# UNITED STATES PATENT AND TRADEMARK OFFICE

APPLICATION NO.	FILING DATE	FIRST NAMED INVENTOR	ATTORNEY DOCKET NO.	CONFIRMATION NO.
10/763,056	01/21/2004	Gary S. Ash	0100.2045-000	3792

**Office Action Summary**

(Partial illustration of Figure 1)

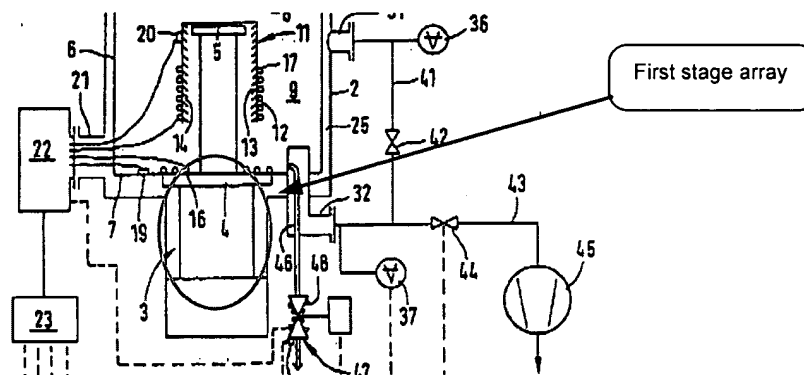
Regarding claim 13, Hafner et al. disclose a closed cycle refrigerator (9 – refrigeration unit); a cooled condensing surface (11 – cold surfaces of the second stage); a pressure gauge (37 – pressure measuring device) sensing pressure in an inner vacuum region (9 – pump interior) (as seen in Figure 1) behind the condensing surface (as seen in Figure 1), the inner vacuum region including an adsorbent (adsorption material; col. 5, lines 25-29); and the sensed region being substantially less than the pressure in an outer vacuum region (25 – space) outside of the condensing surface (see col. 8, line 62 – col. 9, line 9).

Regarding claim 15, Hafner et al. disclose the pressure gauge is connected to a tube or duct (32 – connecting pipe) leading to the inner vacuum region behind the condensing surface (as seen in Figure 1).

Regarding claim 19, Hafner et al. disclose first (as seen in the partial illustration of Figure 1 below) and second stage arrays (13 – inner surface regions) cooled by the refrigerator (as seen in Figure 1), and the second, colder stage further including the condensing and adsorbing surfaces (see col. 5, lines 18-29; Figure 1).

Applicant argues that the pressure sensor (37) would not be able to detect the inner lower pressure region of the pump since there is no duct or other mechanism to separate the pump interior from the insulated vacuum region. This argument is not persuasive. As seen in Figures 1 and 2, the pump interior (9) and vacuum region (25)

are clearly separated from one another via the radiation shield (6), bottom (7) and bellows (26) (see col. 5, lines 5-63). Thus, the rejection is valid and remains.
